Federal and State Agency Comments

Table 4-1. Federal and State Agency Comments Received on the SDIP Draft EIS/EIR

Subject: Draft Environmental Impact Statement (DEIS) for South Delta
Improvements Program, Sacramento-San Joaquin Bay Delta, California
(CEQ# 20050462)

EPA-23

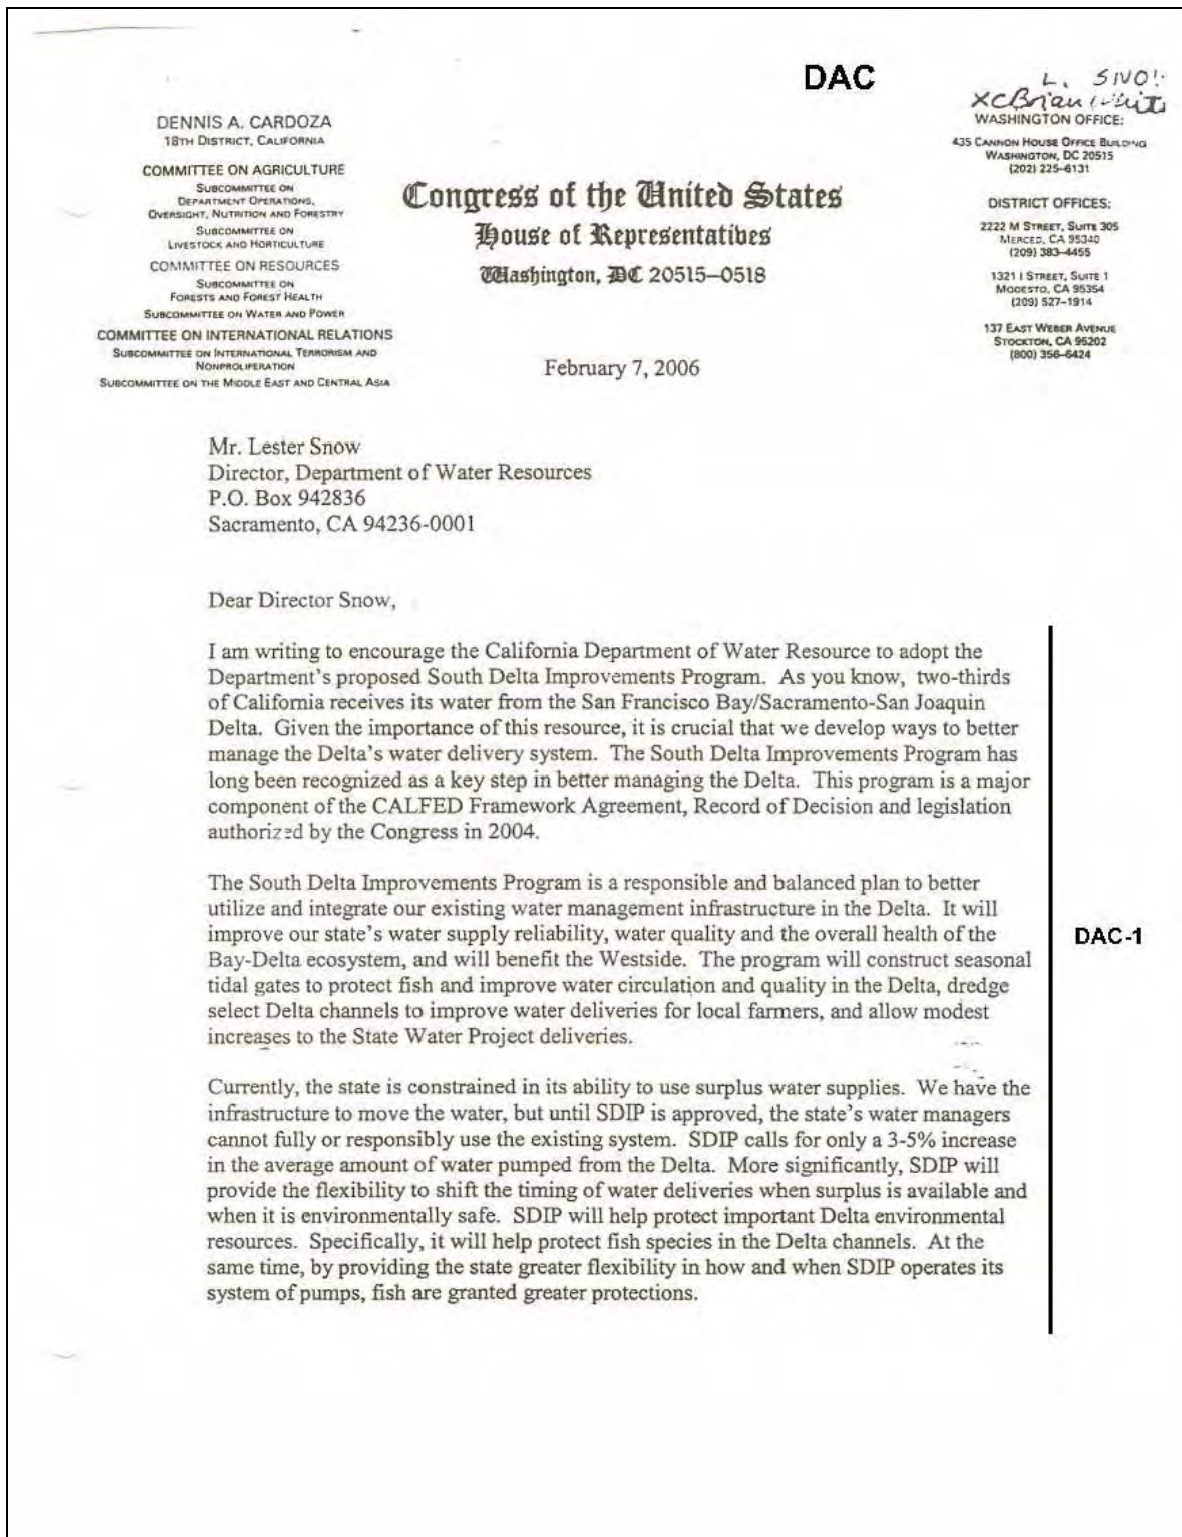
The Stage 1 FEIS and Stage 2 NEPA document should provide a thorough analysis of compliance with the Clean Water Act Section 404 and 404(b)(1) Guidelines for their particular alternatives. If alternatives were evaluated in the CALFED Bay Delta Program Programmatic EIS, that analysis should be explicitly referenced in the Stage 1 FEIS 404 analysis.

Reclamation and DWR submitted a formal CWA application for an Individual Permit to the U.S Army Corps of Engineers, Sacramento District Regulatory Branch earlier in 2006 for the SDIP Stage 1 actions. A CWA permit is required because the constructing the fish and flow control gates and conducting conveyance and spot dredging will result in placing fill in the waters of the United States. Reclamation and DWR are currently in the process of completing the 404(b)(1) alternatives analysis on the SDIP Stage 1 actions. The 404(b)(1) analysis will be submitted to the Corps as part of the ongoing CWA permitting process. The 404(b)(1) analysis was not circulated with the SDIP EIS/EIR. The 404(b)(1) analysis includes a comprehensive evaluation of alternatives, including the alternatives evaluated in the SDIP EIS/EIR.

Alternatives 1, 2, and 3 of the CALFED Bay Delta Programmatic EIS/EIR, included the head of Old River flow control gate and the Middle River, Grant Line Canal, and Old River flow control gates.
